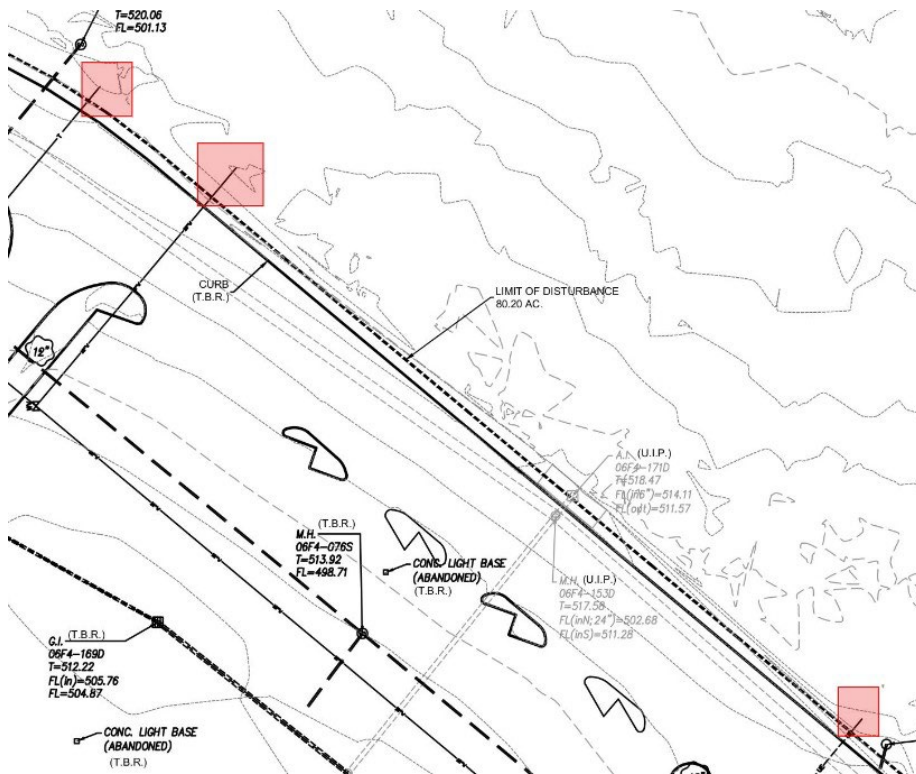
8. Please clarify: in addendum 2 a 3D model was provided. We are seeing discrepancy between the 3D model and existing structure. As an example, the building height shown on 3D model of the four story concrete former Dillard's is shown to be around 40 feet high although in reality the existing building as measured on site is around 70 feet tall. Please clarify the accuracy and intent of the 3D model.

Response: The drone footage is for informational purposes only and should not be relied upon by prospective bidders in calculating dimensions or quantities. It is the responsibility of the prospective bidders to verify existing conditions.
